SOLICITATION AMENDMENT
MODIFICATION DE L'INVITATION

Title - Sujet New 96 Bed Living Unit - PIRTC	
Solicitation No. - N° de l'invitation EZ899-123081/A	Amendment No. - N° modif. 002
Client Reference No. - N° de référence du client	Date 2012-05-01
GETS Reference No. - N° de référence de SEAG PW-\$PWY-005-6657	
File No. - N° de dossier PWY-1-34503 (005)	CCC No./N° CCC - FMS No./N° VME
Solicitation Closes - L'invitation prend fin at - à 02:00 PM on - le 2012-05-08	Time Zone Fuseau horaire Pacific Daylight Saving Time PDT
F.O.B. - F.A.B. Plant-Usine: <input type="checkbox"/> Destination: <input checked="" type="checkbox"/> Other-Autre: <input type="checkbox"/>	
Address Enquiries to: - Adresser toutes questions à: Pillay, Sal (PWY)	Buyer Id - Id de l'acheteur pwy005
Telephone No. - N° de téléphone (604) 775-9386 ()	FAX No. - N° de FAX (604) 775-6633
Destination - of Goods, Services, and Construction: Destination - des biens, services et construction: CSC - Pacific Institution, Abbotsford, B.C.

The following changes in the tender documents are effective immediately. This addendum will form part of the Contract Documents.

SK-1

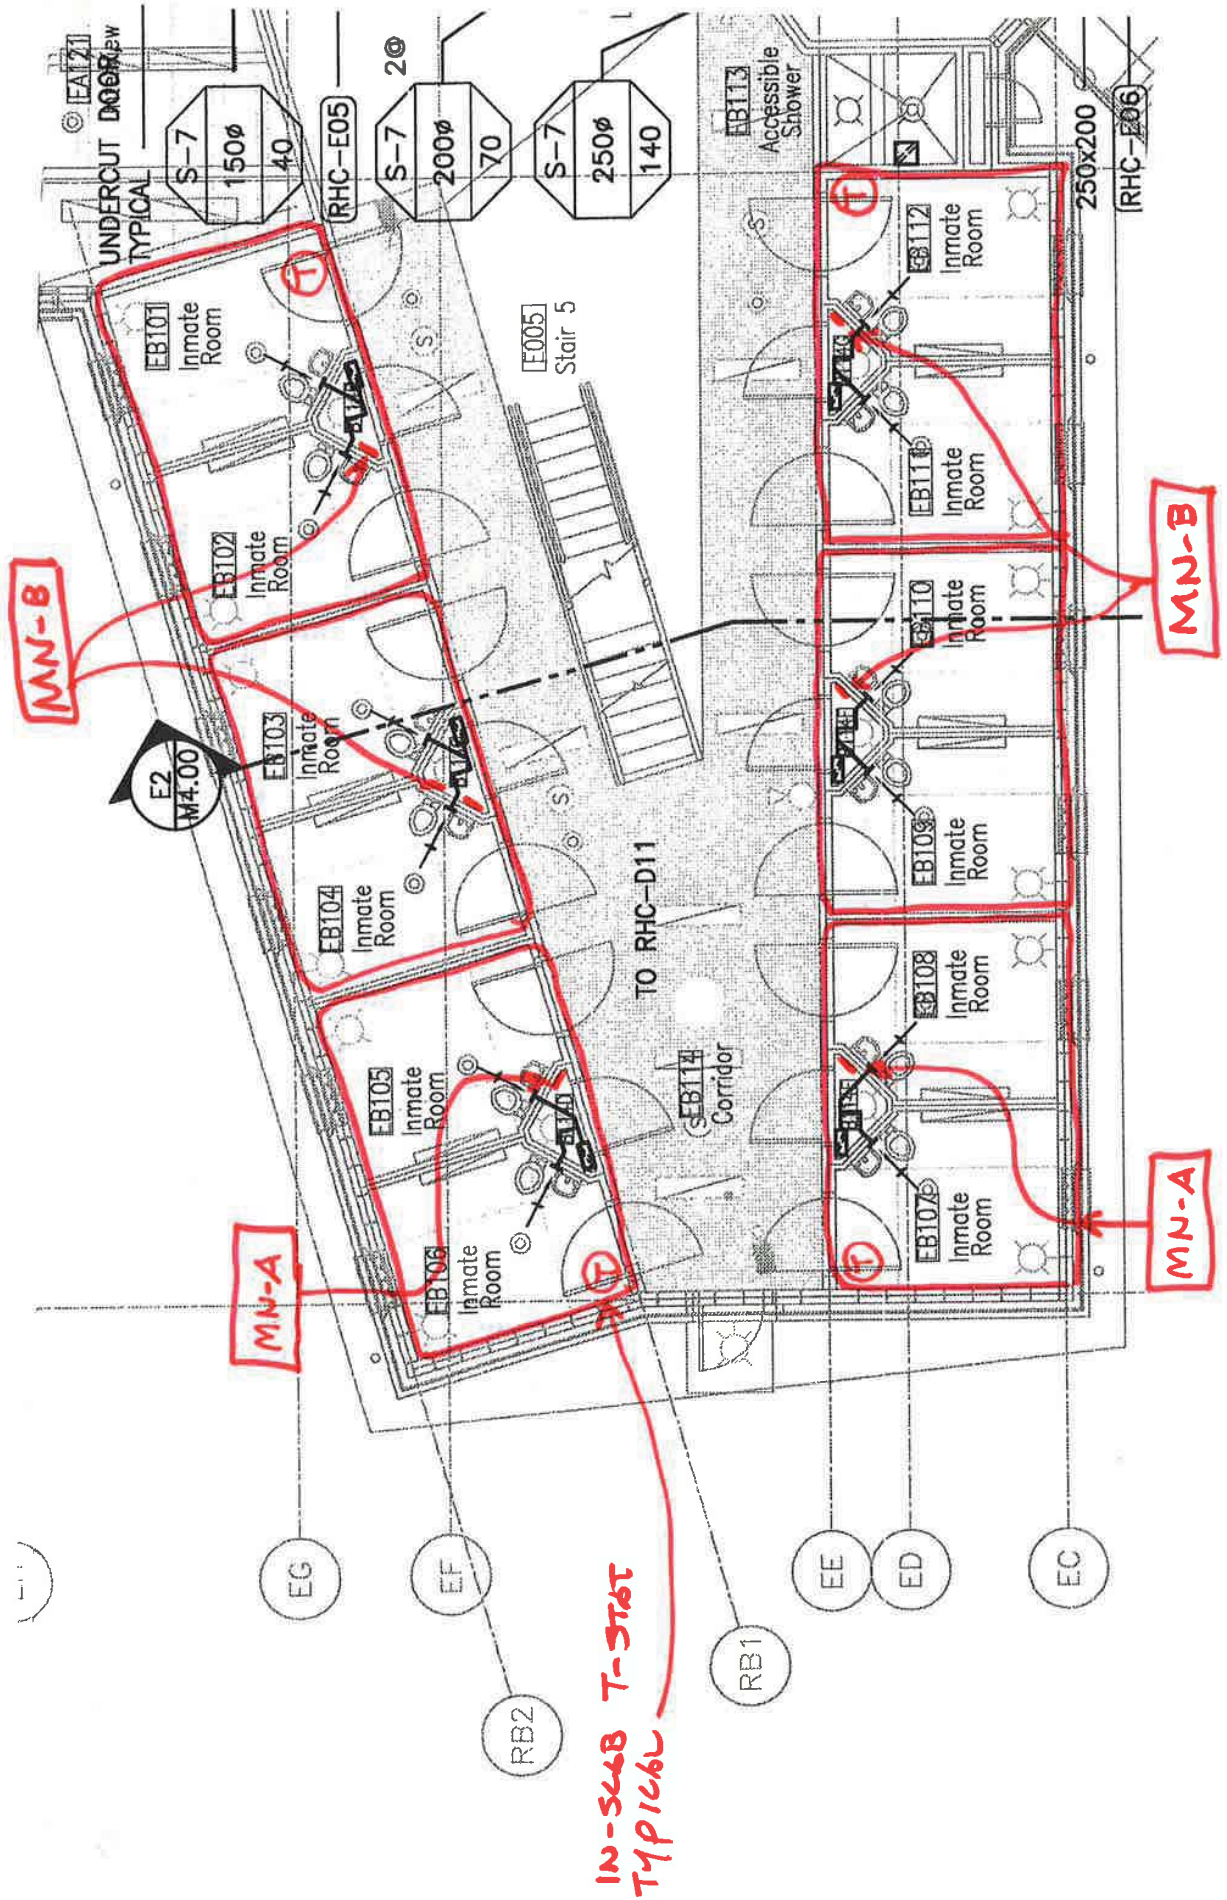
Please provide tag numbers for the Radiant Floor Heating Manifolds and exactly which rooms they serve.

Mechanical Contractor to refer to sketch and schedule attached for typical inmate zones, manifold location, in slab t-stat location and loads as requested.

* TYPICAL MANIFOLD ZONES FOR EXCH RANGE AND BOTH LEVELS
